Text Contribution for P802.1Qdq

12th of November 2021

Toru Osuga, Satoko Itaya, Fumiko Ohori, Takeshi Matsumura (NICT),
Akio Hasegawa (ATR),
Hiroki Nakano (CAHI Corporation)

Figure Y-5A — the worst-case timing of the last frame

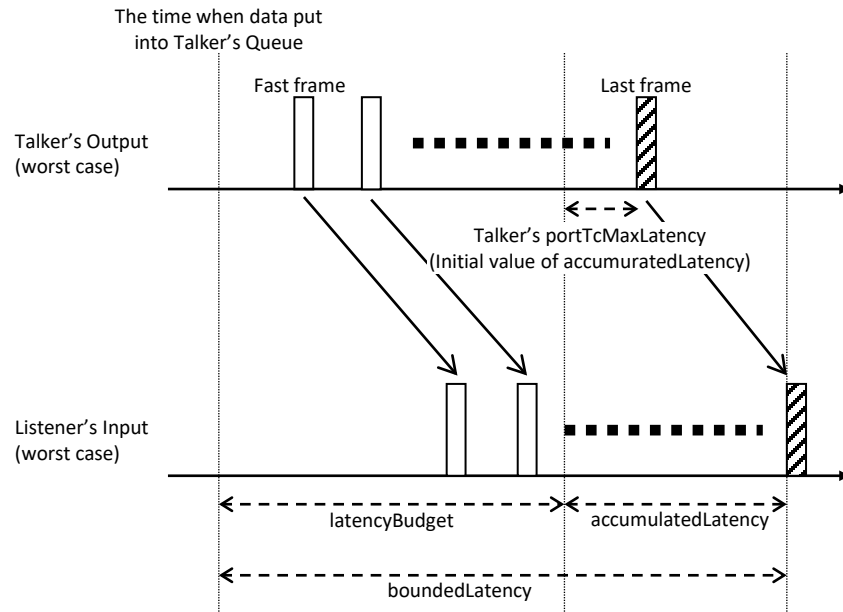
- make clear the relationship among bounded latency, accumulatedLatency, and latency caused by shaping
- review technical terms:
 - replace the term “targetLatency” with “latencyBudget”
 - use the correct term (MaxLatency -> accumulatedLatency)

- We propose to replace Figure Y-5 with the following two figures:

Figure Y-5B — the worst-case budget calculation

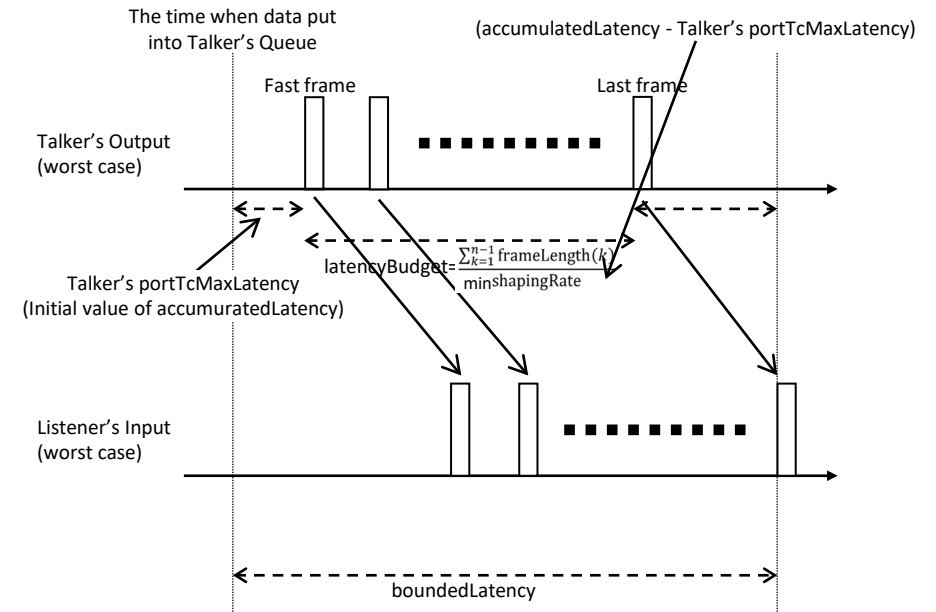
- In the second paragraph of Y.4.1, describe the definition of latencyBudget (formerly targetLatency) as follows:

In order to minimize over-provisioning of bandwidth reservation while ensuring the ~~requirement for the delivery time is met~~ specified bounded latency, the bursty traffic should be shaped with the minimum shaping rate ~~within the required bounded latency~~ (required ~~m~~Minimum ~~s~~Shaping ~~r~~Rate). Figure Y-5A illustrates worst-case ~~Frame~~ propagation of the last frame of a cluster comprising n frames within the given bounded latency while minimizing over-provision of bandwidth reservation ~~is illustrated in Figure Y-5~~. accumulatedLatency is given by the network. latencyBudget is the maximum duration while Talker emits $(n-1)$ frames. ~~and referred to as the target latency. From Figure Y-5, the target latency~~ Figure Y-5B shows latencyBudget can be derived from bounded latency and accumulatedLatency. The ~~required~~ minimum shaping rate for traffic shaping is equal to:
